APPROVED MINUTES OF THE MEETING

December 3, 2009

December 3, 2009 **Project:** **Westlake Transportation Hub Strategy**

Phase: 60% Design

Figure 1: Big Tree/Water Splashes” alternative

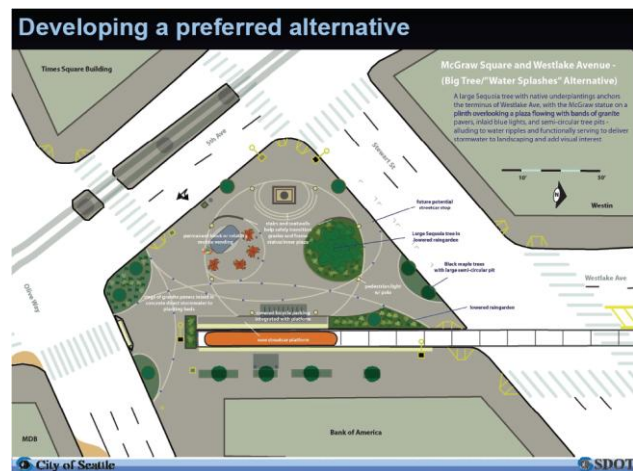
- There is some concern about the sequoia tree. It is suggested that the team look at a “grove” approach.
- The use of colored lights at night could become a strong focal point but it should be approached with care.

- Optimize the design to be compatible with the streetcar expansion.
- Emphasize another look at the water channels and whether they are functional or just decorative. They should express the drainage pattern and not an arbitrary geometry.

Regarding the water channels, how will the granite pavers work to channel water when not all are connected? Is this still just highly conceptual?

Why was a sequoia tree chosen?

Did you consider a cluster of trees?

This particular rendering is conceptual and these details are being worked out. However, the channels won't be entirely functional. Three main catch areas but some channels remain purely visual.

It is a strong tree that is iconic and long lasting.

There is a chance they might be crowded and might not survive and therefore, maintenance would have to increase."
